Access Compliance Report

Public Rights-of-Way

(Curb Ramps)

Intersection ID: 10023820	Main Street: COLONY_RD	Cross Street: N/A	Location: SE
ADA ID: 7280B0C94D40	Ramp Type: Perp	Initial Pass/Fail: Fail	Overall Compliance: No
Severity Score: 21.25			
Codes/Mitigation Info/Possible Solution		Field Measurements/Component Compliance

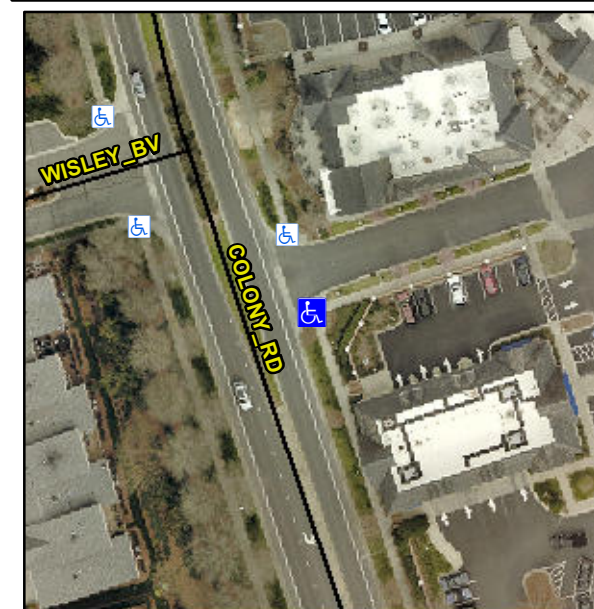
Not Found, R304.5.1, R304.5.3

Compliance	Description	Data	Compliance	Description	Data
N/A	Ramp Length (in)	56.0	Yes	Ramp Slope (%)	5.2
No	Ramp Width (in)	40.0	No	Ramp XSlope (%)	6.7
N/A	Flare Type LT	N/A	N/A	Flare Type RT	N/A
N/A	Flare Slope LT (%)	N/A	N/A	Flare Slope RT (%)	N/A
N/A	Flare Traversable LT?	N/A	N/A	Flare Traversable RT?	N/A
N/A	Landing Length (in)	N/A	N/A	DWS Provided?	N/A
N/A	Landing Width (in)	N/A	N/A	DWS Contrast?	N/A
N/A	Landing Slope (%)	N/A	N/A	DWS Length (in)	N/A
N/A	Landing X Slope (%)	N/A	N/A	DWS Full Width?	N/A
N/A	Landing Curb? (Y/N)	N/A	N/A	DWS Offset (in)	N/A
N/A	Shared Landing?	N/A			
N/A	Gutter Ponding?	N/A	N/A	Gutter Slope (%)	N/A
N/A	Gutter Lip Ht (in)	N/A	N/A	Gutter X Slope (%)	N/A
N/A	Painted X Walk1?	No	N/A	Painted X Walk2?	N/A
	X Walk 1 Direction	To N		X Walk 2 Direction	N/A
N/A	X Walk 1 Width (in)	N/A	N/A	X Walk 2 Width (in)	N/A
	X Walk 1 Slope (%)	0.1		X Walk 2 Slope (%)	N/A
	X Walk 1 X Slope (%)	4.8		X Walk 2 X Slope (%)	N/A

Remove & Replace Entire Ramp.
